From: Gary Obery <garyobery1@gmail.com>
Sent: Friday, April 06, 2018 9:30 AM
To: Anthony Gamallo; citycouncil
Subject: Winter-Maple Bicycle and Pedestrian Plan
Attachments: two-way and four-way stop Concerns.pdf

Area of Concern	Winter-Maple Bicycle and Pedestrian Plan: Stop Signs Needed	
From	Gary Obery, Highland Neighborhood resident	April 6 th , 2018
To	Salem City Council	
WMB Final Draft	 <div style="display: flex; justify-content: space-around; margin-top: 10px;"> <div style="text-align: center;"> <p>Maple & Johnson St Shown as uncontrolled "T" intersection in WMB Concept Plan</p> </div> <div style="text-align: center;"> <p>Winter & D Streets Shown as 2-way Stop In WMB Concept Plan</p> </div> </div>	
Support	The plan addresses the need for some new STOP signs at several intersections along the WMB route including side streets at Academy and at Hickory, and for turning the stop signs at Cottage/Jefferson.	
Concerns	<p>1. City Public works staff have suggested that it is beyond the scope of this planning effort to make recommendations regarding the use of STOP signs at some of the intersections along the WMB. I will offer, however, that one of the central elements to a successfu

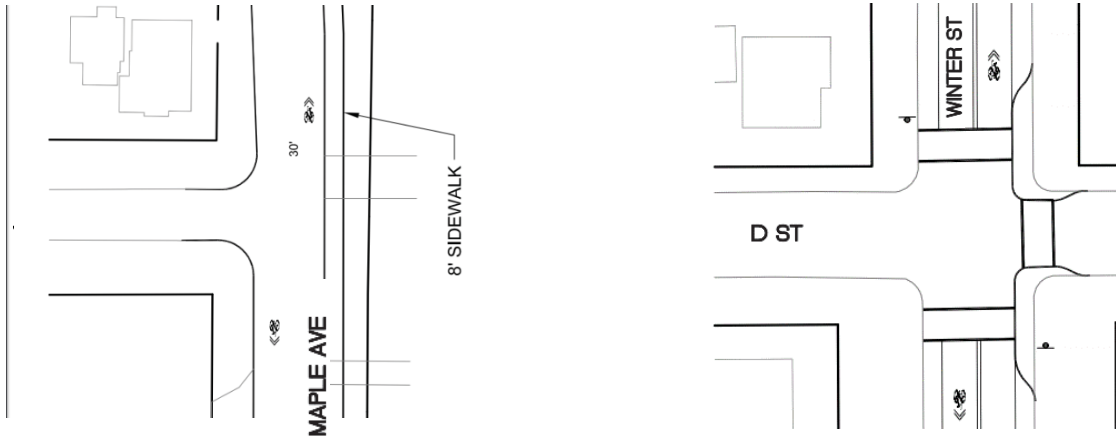
<p>are too high for bicyclists and pedestrians to cross them comfortably. While crossing them in a car may feel comfortable, the experience is quite different on foot or on a bike. Traffic volumes and speeds are not likely to change on D or on Highland as a result of the traffic calming and other treatments planned for the MWB; it will be just as difficult to walk or bike across these intersections after improvements are made to the MWB as it is now. All of the necessary data and factors that should be considered when making this recommendation are included in the draft plan or can be accessed from the city's traffic count database. While traffic volumes are suggested as one of the factors that should be considered in an engineering study, they are not the only factor that can be used to justify a four-way stop. The MUTCD (Section 2B.7) states that "The need to control vehicle/pedestrian conflicts near locations that generate high pedestrian volumes" may be used to justify a four-way stop.</p> <p>In addition to claiming that these intersections do not meet "warrants" for a four-way stop, city staff have suggested that this document is a planning document and that the engineering study required to establish justification for the use of a four-way stop is beyond the scope of this document. My response to those points is that the draft MWB plan is already effectively serving as the engineering study for a number of similar recommendations including the mini-roundabout at Winter/Union, for the marking of crosswalks at Fairgrounds and at Pine Street, for turning the STOP signs at Cottage/Jefferson, and for the proposed exclusive bicycle signal phase at Cherry/Auto Group Road. While the plan is not intended to address engineering design questions, it is very much intended to serve as an engineering study. Indeed, the technical memos that were prepared for this project were stamped by a Registered Professional Engineer with special expertise in Traffic Engineering. This document is the appropriate vehicle to make engineering recommendations regarding the use of STOP signs along this route. Now is the time for the city to establish its preferred option for treatment of these intersections.</p>

Request	<p>1..Include the addition of STOP signs to Academy, Spruce, Hickory, Johnson, and Tryon Streets at Maple Avenue as part of the WMB plan.</p> <p>2. Include the addition of four-way stops at Winter & D Street, and at Maple & Highland as part of the WMB plan.</p>
